COUNCIL ASSESSMENT REPORT

Panel Reference	PPS-2018STH027
DA Number	10.2015.2000498.3
LGA	Snowy Monaro
Proposed Development	Extractive Industry – Modification and Deletion of Conditions
Street Address	Lot: 160 DP: 724552, Lot: 159 DP: 724552
Applicant/Owner	Snowy Monaro Regional Council/ N W Walters & M Walters
Date of DA Lodgement	17/09/2018
Number of Submissions	Four (4)
Recommendation	It is recommended that the application be approved in part by deleting condition no. 5 and amending condition no. 20 all other conditions subject to the modification application should remain unchanged.
Regional Development Criteria (Schedule 7 of SEPP (State and Regional Development) 2011	Under the provisions of Part 4 clause 20 (1) of State Environmental Planning Policy (State and Regional Development) 2011 "Extractive Industries " are considered regionally significant development in accordance with Schedule 7, 7(a) if they meet the requirements for designated development.

4.55(2) ASSESSMENT REPORT

Application No:	10.2015.2000498.3
Planning Portal Reference:	PPS-2018STH027
Date of lodgment:	17/09/2018
Development proposal:	Alterations and Additions to Extractive Industry (Modify Conditions)
On

Figure 4 – Showing Extraction area staging and proposed screening options (source – NGH Visual Impact Assessment)

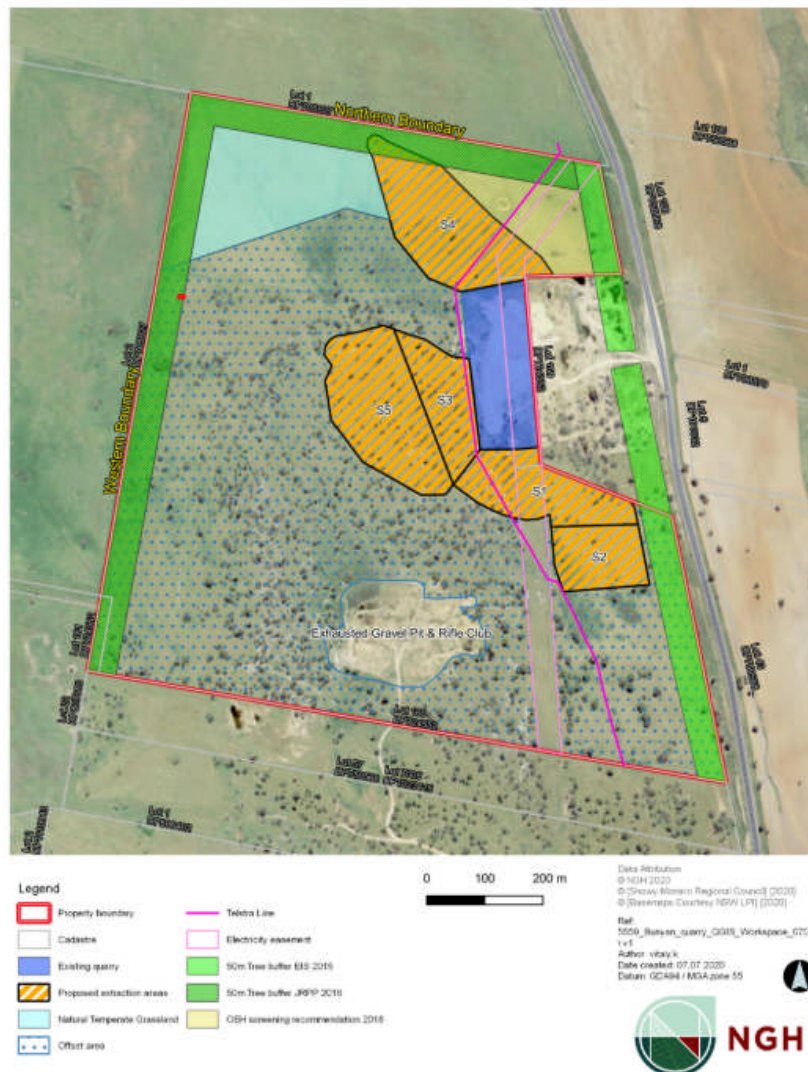
The VIA reviewed the modification proposed to condition 20 and concluded the following:

- Although the proposed gravel pit expansion is considered to have good visual integration, safeguards have been included to provide assurance about further minimisation of visual impacts. This includes additional screening to what was outlined in the EIS (NGH, 2015).*
- Viewpoints 1,3,6, 7, 8 and 9 were assessed to have a low visual impact due to the topography, and vegetation resulting in high integration or no views. Specifically, for viewpoint 1, it was identified that the proposed 50m wide tree corridor required as part of the EIS (NGH, 2015) along the eastern boundary would further integrate the gravel pit with the surrounding landscape.*

As such the VIA concludes that the mitigation measures outlined in the original EIS and assessed as part of the development application in the first case are still applicable. However it is recommended that some additional screening is installed as per advice from OEH. This area is shown in figure 3 above. The additional mitigation measures proposed through the VIA are as follows and have been included in the amendments recommended for condition 20:

- A vegetation buffer would be planted in stages to correspond with the staged expansion areas. The trees are to be planted in conjunction with extraction Stages 1 and 2.*

- Rapid implementation of rehabilitation actions (refer to Section 6.1), for areas where extraction has ceased. New areas should not be expanded until funds and planning for exhausted areas can be demonstrated.*

- In addition to the 50m tree buffer along the highway, Council will undertake further canopy and understorey planting north of the existing gravel pit. There are existing mature trees in this locality indicating this would have been Tablelands Snow Gum Grassy Woodland. Staff from the OEH has been onsite and are in full support of this option. Refer Attachment A, letter of support from OEH.*

- Council would establish an earth bund around the existing gravel pit site to offer visual screening of the extractive industry. Fast growing understory native plants (Acacia species) could be planted at the base of the bund.*

It is recommended that condition 20 be amended to remove the additional buffer planting above that which was shown on the approved plans and to include recommendations provided in the Visual Impact Assessment. This will require adding additional parts to condition 20 to facilitate compliance with the recommendations in the VIA. The VIA addressed the requirements set out in condition 20 and the proposal to remove this condition. It found that an extension of the tree buffer along the entire length of the northern and western boundary as is required in condition was not warranted. Whilst the recommendation is that the additional planting along the entire length of the northern and western boundary is not supported by the VIA it does include a recommendation that some additional planting be included in the in the north eastern portion of the site, in close proximity to the boundary. This alternative planting was suggested in correspondence to the applicant from OEH. This will allow for this additional screening will also meet the reason for JRPP Condition of Approval 20 'To ensure the extractive industry is visually screened from the Monaro Highway'. The additional screening along the northern boundary will visually screen the extractive industry from the highway and receivers along the highway specifically R2 and R35. In addition it is important to protect the existing vegetation on the western slopes as it provides screening to the dwellings to the west of the site.

- 20 The '50 metre tree buffer' area, shown in Figure 2-3 of the approved Environmental Impact Statement is to be expanded by further canopy and understory planting to the north of the existing gravel pit. The additional planting to be established in accordance with the requirements of the Visual Impact Assessment (NGH, August 2020).
Reason: To ensure the extractive industry is visually screened from the Monaro Highway.

- 20b An earth bund shall be established around the existing gravel pit site to offer visual screening of the extractive industry. Fast growing understory native plants (Acacia species) are to be planted on the bunded area.
Reason: To ensure the extractive industry is visually screened from the Monaro Highway.
